Office Action Summary

10/792,326

DREW ET AL.

DETAILED ACTION

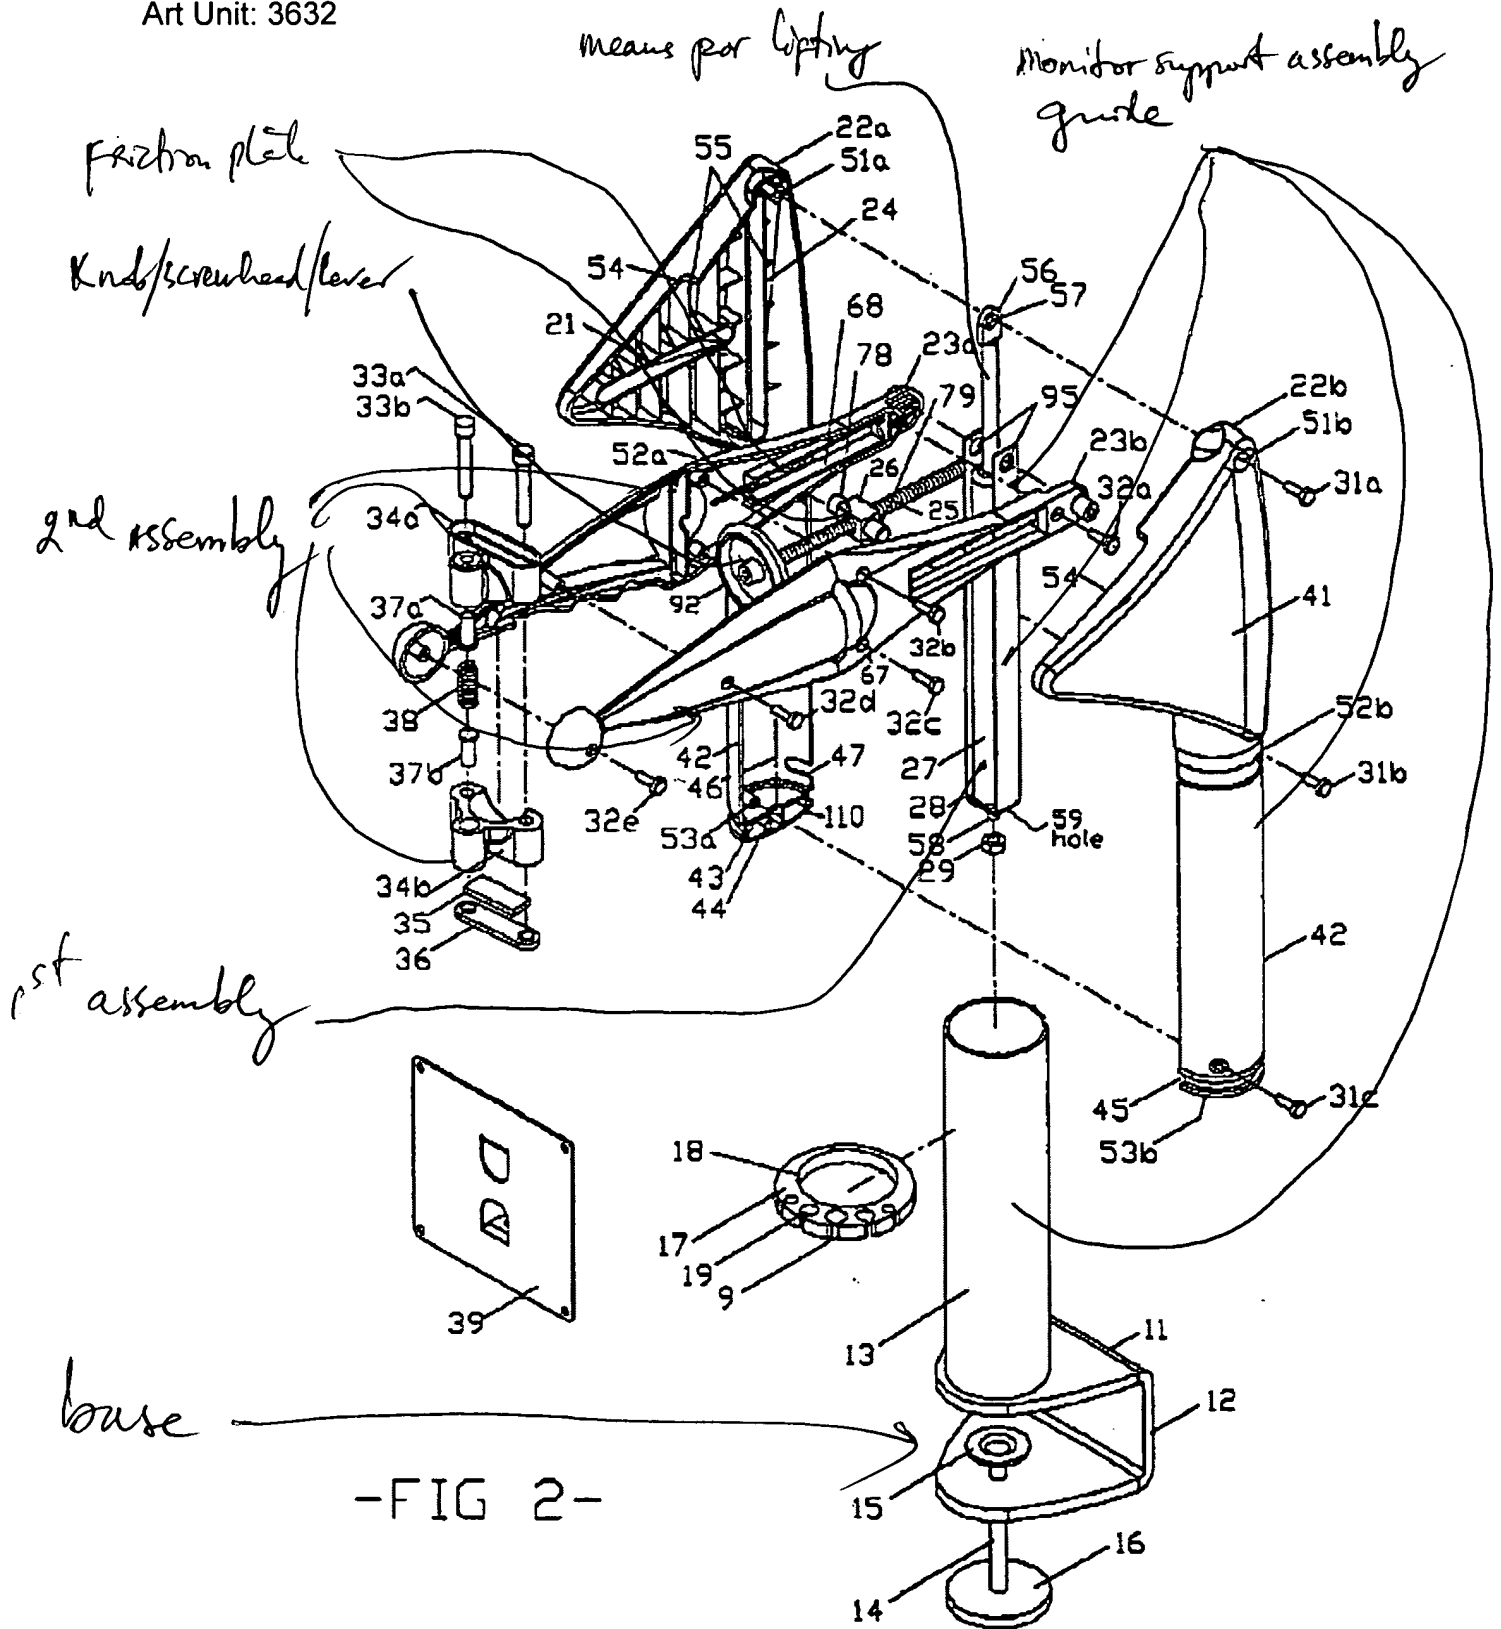
All limitations in claims 1-20 are substantially disclosed in the prior art of Conner et al as illustrated below.

Note: regarding claims 3-4, 10-11 the monitor support assembly of Conner et al. can be moved vertically by applying a force with a vertical component of more or less than 10 Newtons.
